Staff recommends preliminary plat approval of Vaquero Village Cluster Subdivision (13 lots). This recommendation for approval is subject to all review agency requirements and based on the following conditions:

Exhibit B-Review Agencies Comments

Project: Vaquero Village Cluster Subdivision

Photo of the proposed subdivision

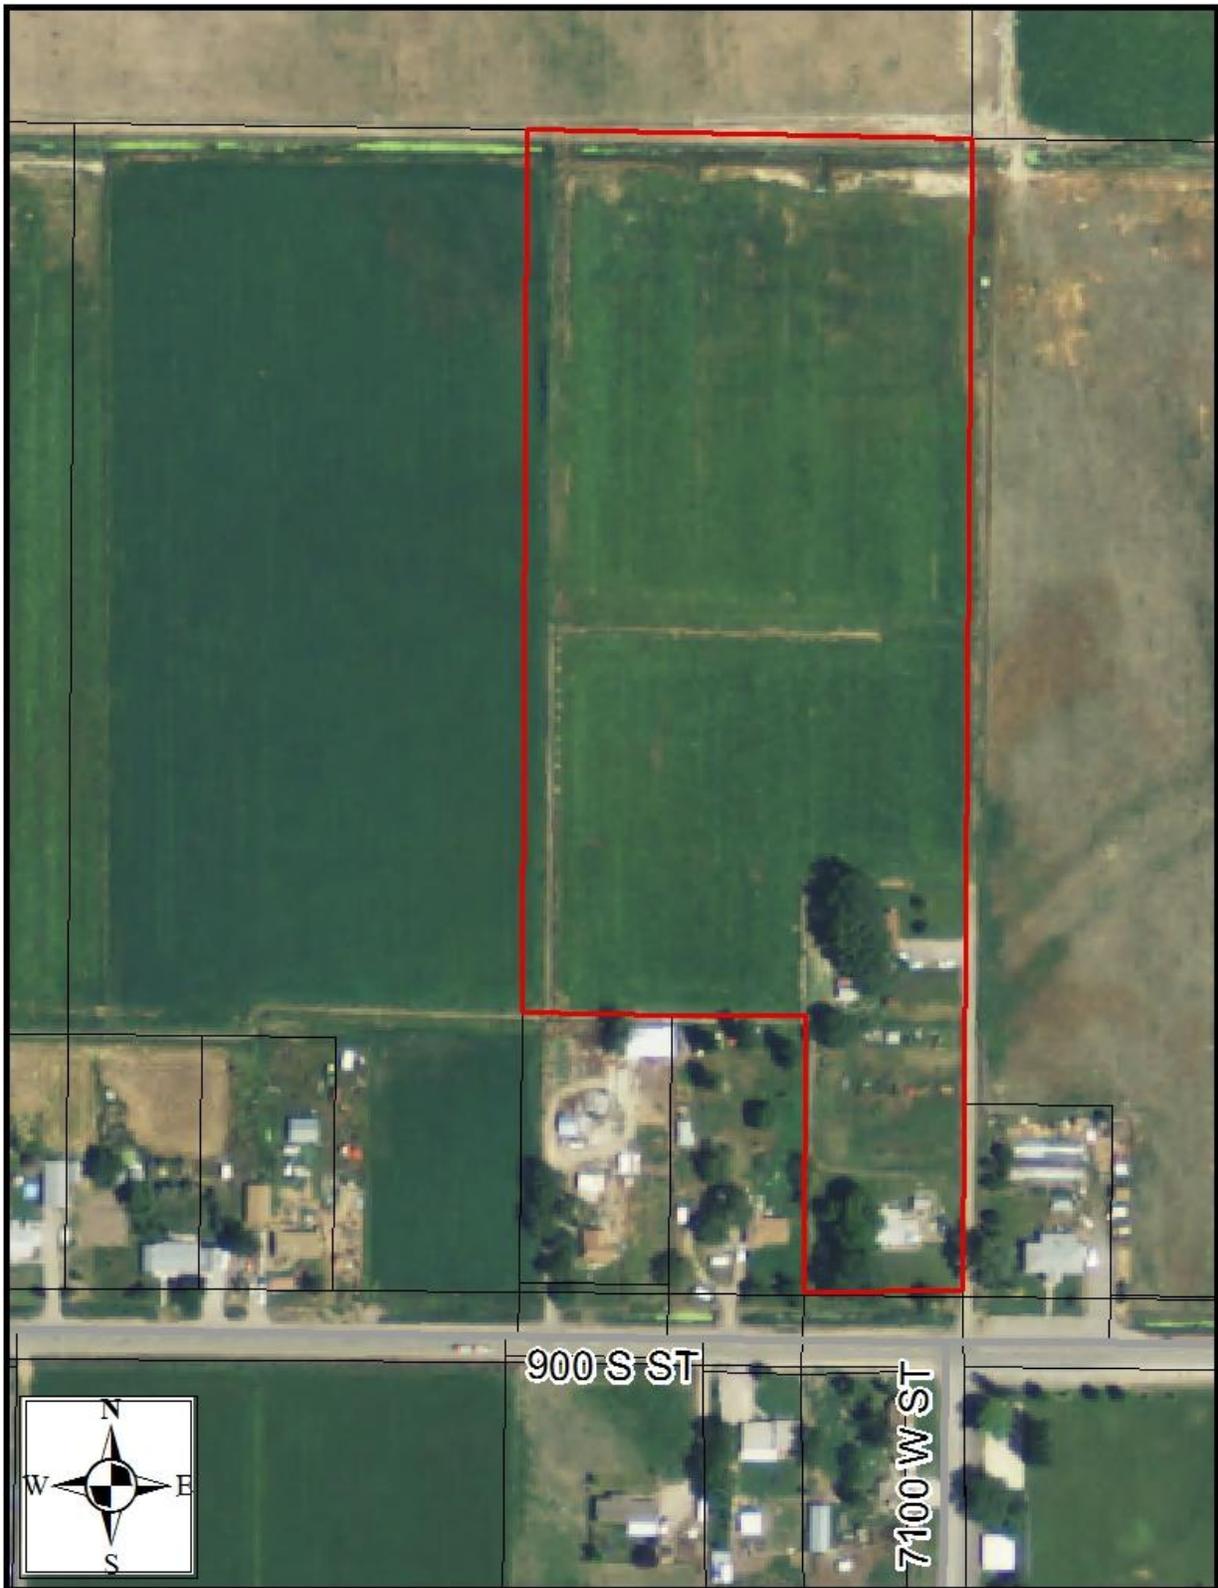
Access: A new section of road is proposed with this subdivision which will provide access and frontage to all 13 lots. The new roadway would extend north from 900 South at 7100 West, completing an intersection at 7100 West. The roadway will be 66 feet wide and will stub to the end of the property with a temporary turnaround. About halfway down the roadway a small cul-de-sac would branch off to the west, and will be 50 feet wide.

Cluster Subdivision: The proposed project will occupy 12.89 acres and consist of 13 lots, with 4.14 acres (32.1%) of common area which will be open space. The proposal meets the requirement of 30 percent open space. The lots are centered in the subdivision design and surrounded by 50 feet of common area. This area will be maintained by a Home Owners Association. The subdivision will be serviced by approximately 2.62 acres of public road improvements. The property has 10.27 acres of net developable area once the road is subtracted. Since the zoning requires 40,000 square feet of area, 11.18 lots would be allowed on this property. The applicant is asking for a 25 percent density bonus by proposing public access to the open space (15%) and by meeting the purpose and intent of a cluster subdivision (10%). To reach the requested 13 lots the subdivision will not use the full 25% bonus density and only requires a bonus density of 16.3 %. The Planning Commission will need to determine if the proposal is sufficient for the requested bonus density. A Home Owners Association will be created with specific Community Covenants and Restrictions

Lot area, frontage/width and yard regulations: The minimum frontage in a cluster subdivision is 60 feet. The yard setback standards are 20 feet on the front and rear yards to the lot line, and the side yard are minimum of 8 feet each. Dwellings are allowed to be an average height of 40 feet. The 13 lots range from 20,000 square feet to 21,000 square feet meeting lot area and frontage requirements of the cluster subdivision code and Health Department requirements for individual septic systems. As there were multiple structures previously built on this property, all structures must meet setback requirements for each lot they are on if they are to remain. If not, they will need to be removed, or adjustments made to the plat to meet yard setback regulations.

Subdivision: The improvement plans include the main road's width to be a 66 foot right of way, while the small cul-de sac has been reduced to a residential 50 foot right of way width. The plans include curb, gutter, and sidewalk on both sides of the street. It also includes 13 street trees and grassed park strips. Six lamp posts have been proposed to be placed along the main roadway. The landscaping plan also includes a three foot wide crushed gravel trail in the common area along with many other trees surrounding the subdivision. The applicant has not expressed at this time whether the common area will be turf grass, pasture grasses, or some other type of ground cover. A more detailed plan will be required before final approval listing the size, type and quantity of landscaping. All improvements need to be either installed or escrowed for prior to recording of the subdivision.

Additional design standards and requirements: A large irrigation ditch crosses along the north boundary of the subdivision. Irrigation ditches or canals which carry five second feet or more of water is required to install a solid board, chain link, or other non-climbable fence not less than five feet in height. Therefore, if required by the volume of water, the applicant will have to install a non-climbable fence of not less than five feet along this irrigation ditch.
